# SADDLEHORN RANCH FILING NO.3

## A PARCEL OF LAND LOCATED IN THE NORTH HALF AND THE SOUTHWEST QUARTER OF SECTION 3, TOWNSHIP 13 SOUTH, RANGE 64 WEST OF THE 6TH PRINCIPAL MERIDIAN, COUNTY OF EL PASO, STATE OF COLORADO

# ENG-SF23004-R6\_Final Plat.pdf Markup Summary

JOB NO. 25142.05  
JULY 19, 2023  
SHEET 3 OF 5

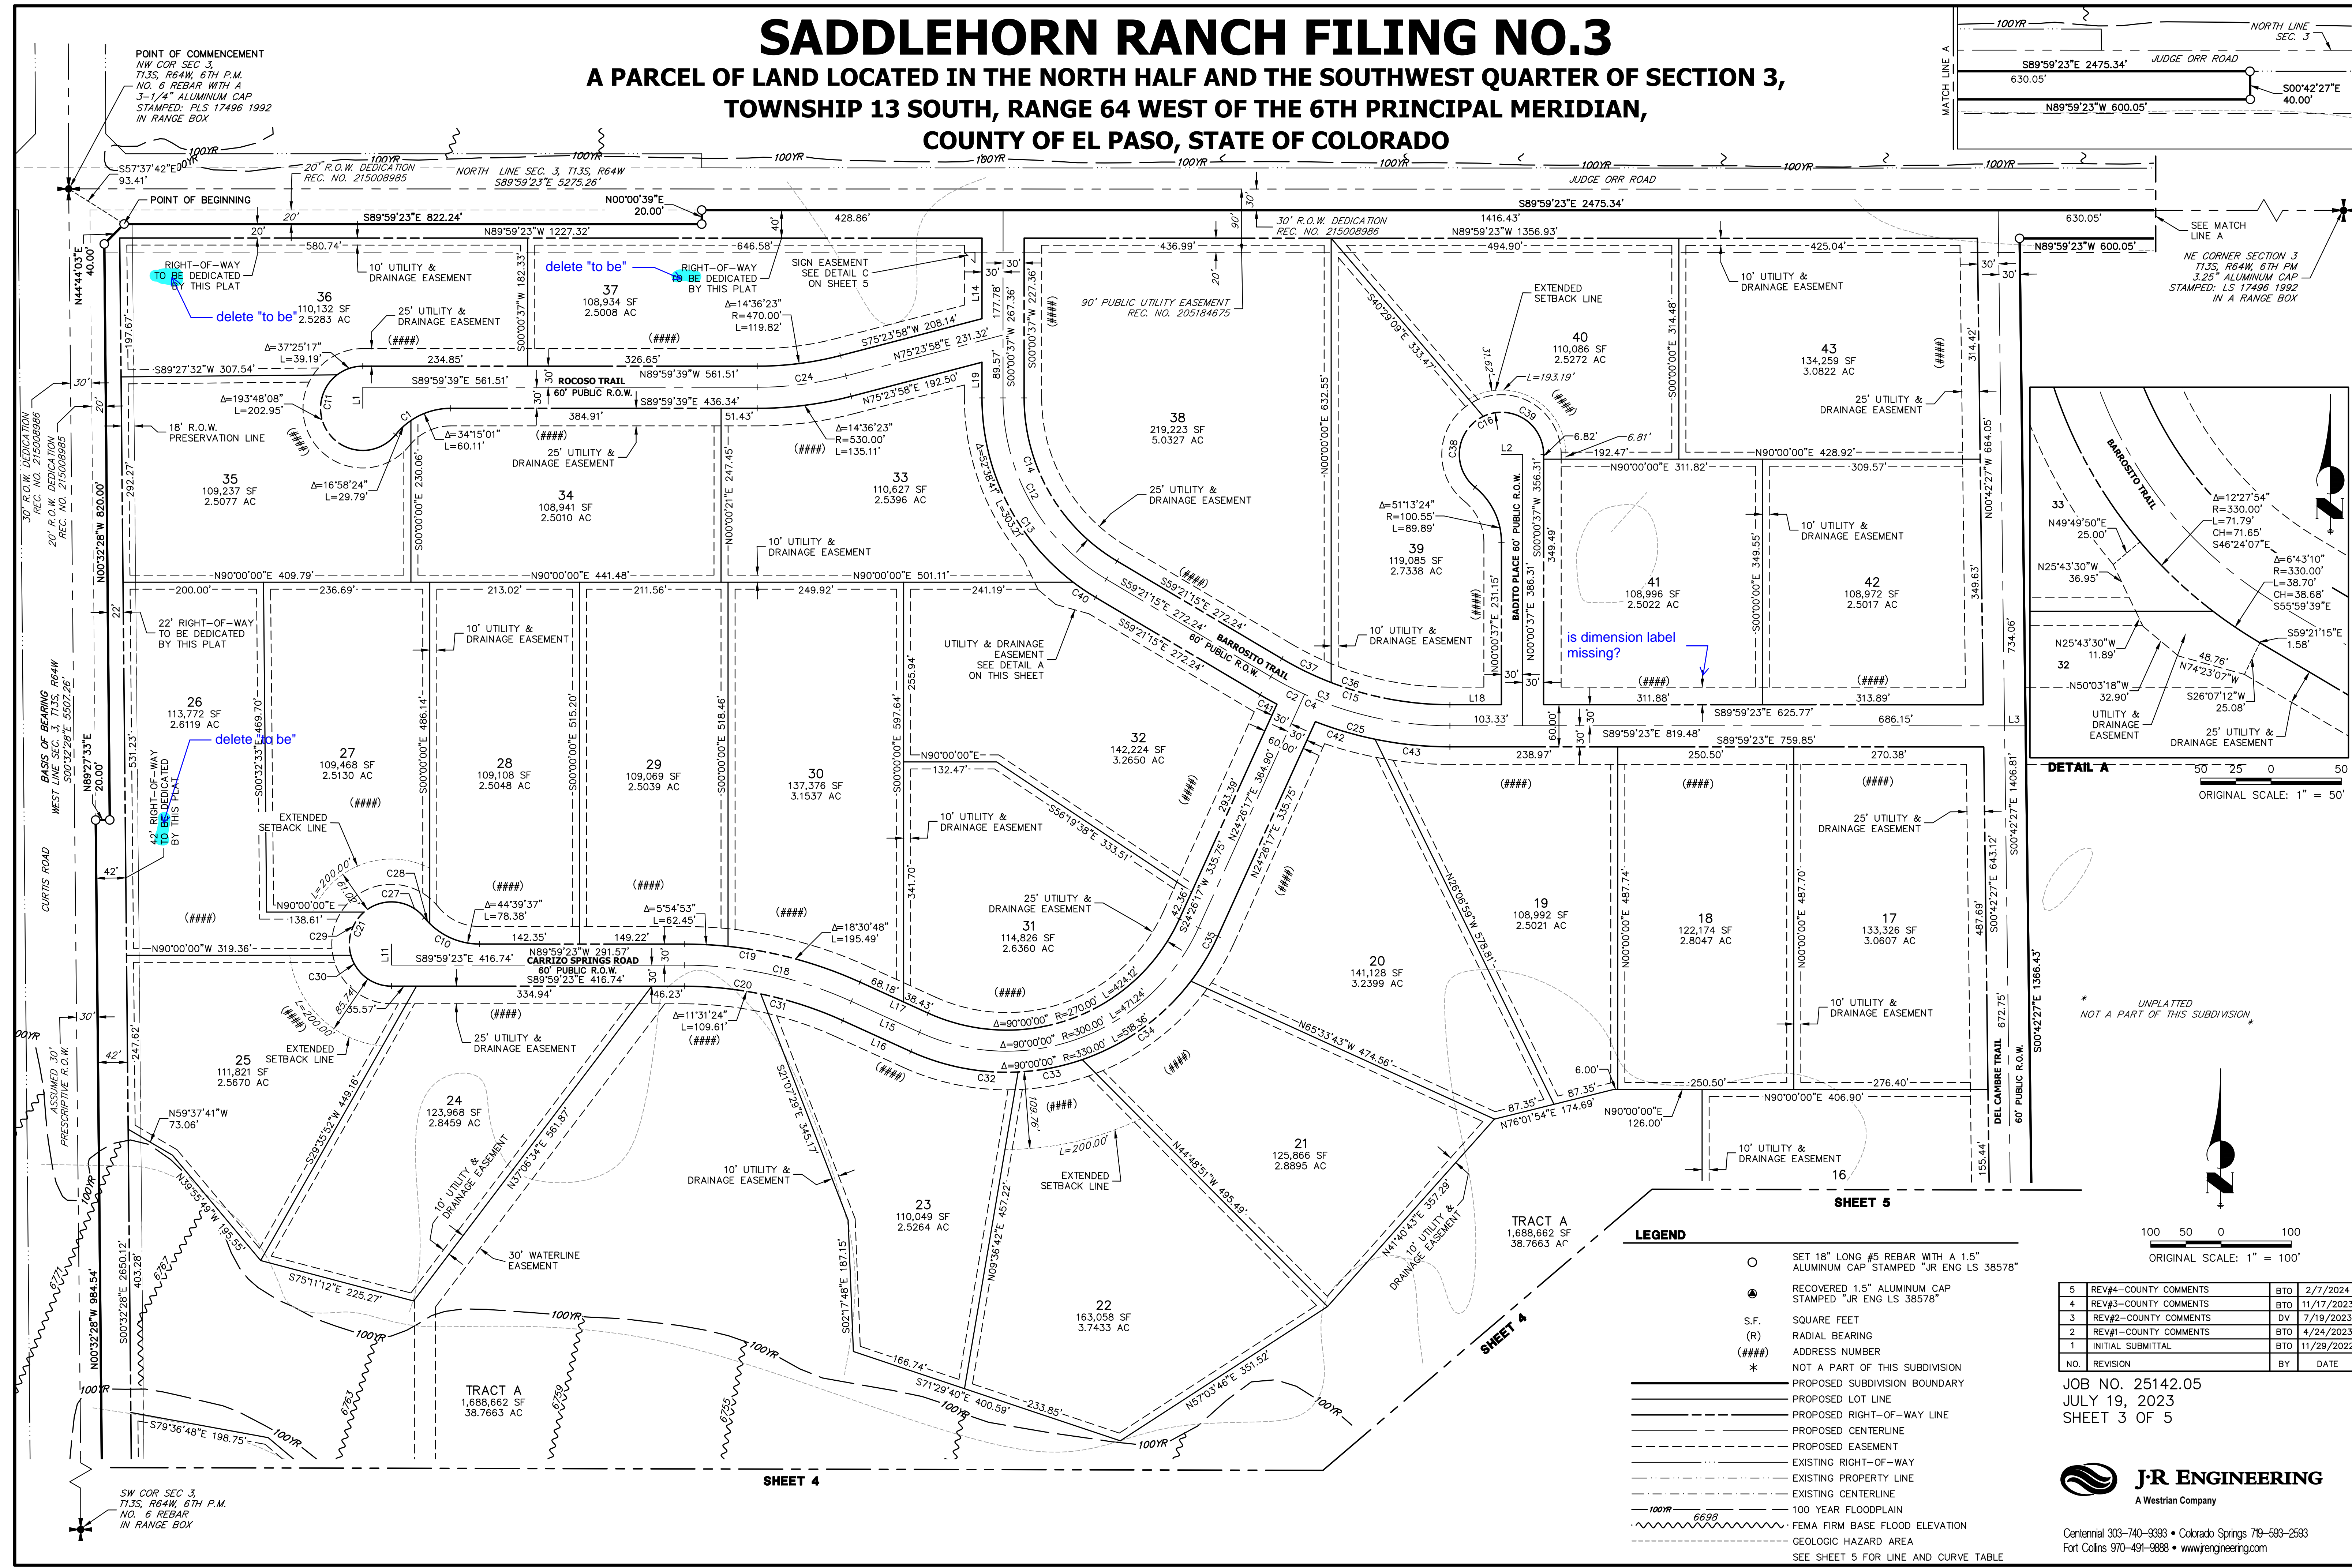
delete "to be"

delete "to be"

delete "to be"

delete "to be"

delete "to be"

is dimension label missing?

JOB NO. 25142.05  
JULY 19, 2023  
SHEET 4 OF 5

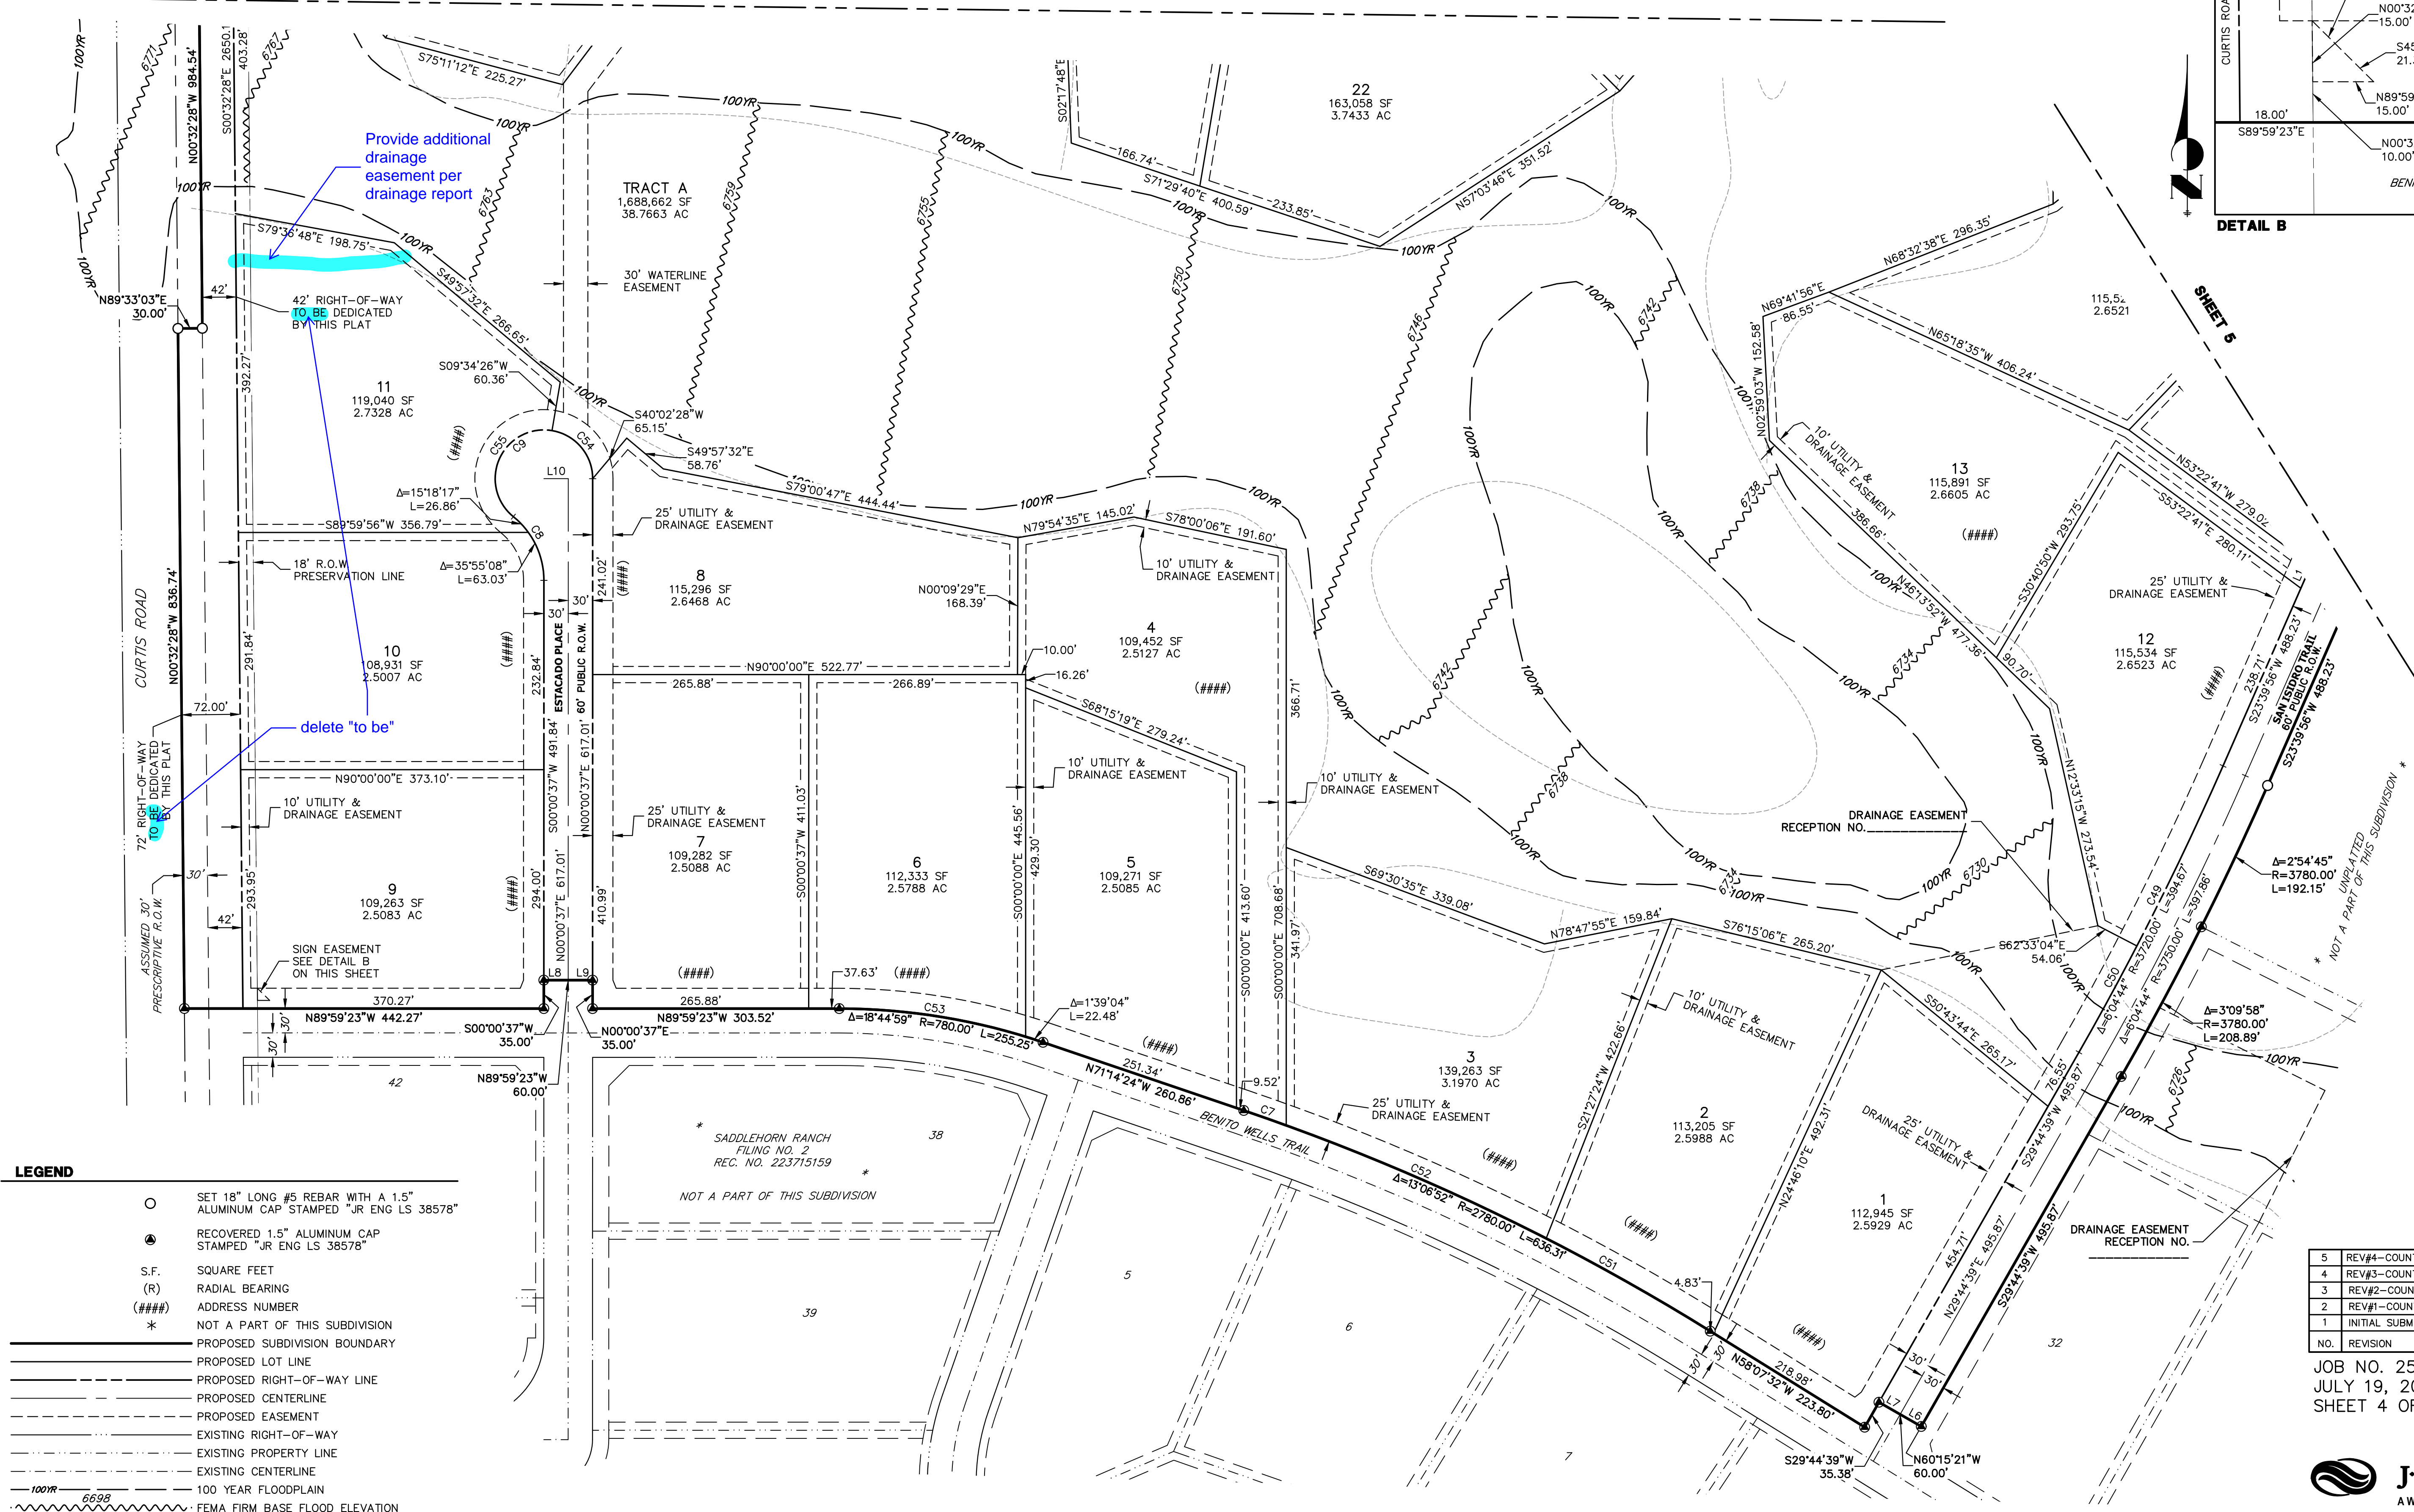
Provide additional drainage easement per drainage report

delete "to be"

delete "to be"

Provide additional drainage easement per drainage report
